Appendix C: Fort Collins Streetscape Design Standards

(Text changes are in red)

- Add newest cobble mulch detail and newest boulder detail

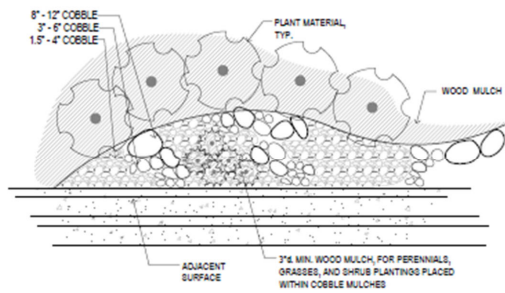
Add details

- on truck pullout on median (Horsetooth and Lemay)

Commented [AW49]: @Jill Wuertz Is this the truck pull out you want to detail? I can't find it in the plans on the P: drive.

Commented [JW50R49]: @Aaron Wagner yes, thanks, dwgs are here: P:\Medians\ALL PROJECTS\PARKS_Horsetooth & Lemay
